HIGHWAY WORK PROPOSAL

| <u>COUNTY</u> | <u>STATE PROJECT</u> | <u>FEDERAL</u> | <u>PROJECT DESCRIPTION</u> | <u>HIGHWAY</u> |
|---------------|----------------------|----------------|--|----------------|
| Shawano | 6580-10-71 | N/A | Clintonville - Howard; Herman Creek Crossing B-58-0019 | STH 156 |

**Addendum No. 01
ID 6580-10-71
Revised Plan 47
January 7, 2022**

CROSS SECTION & QUANTITIES
SHEET 2 OF 15
47

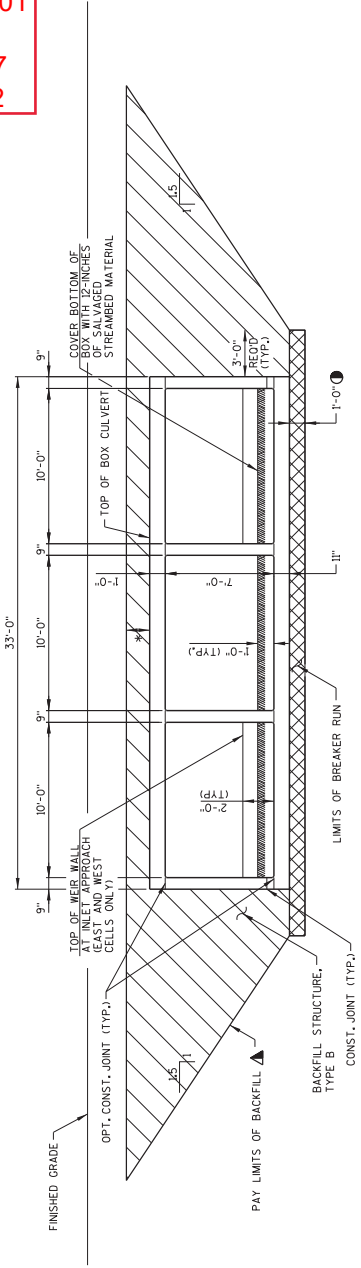
| Revised Plan Sheets | |
|---------------------|---|
| 47 | Revised note to clarify salvaged stream bed material is incidental. |
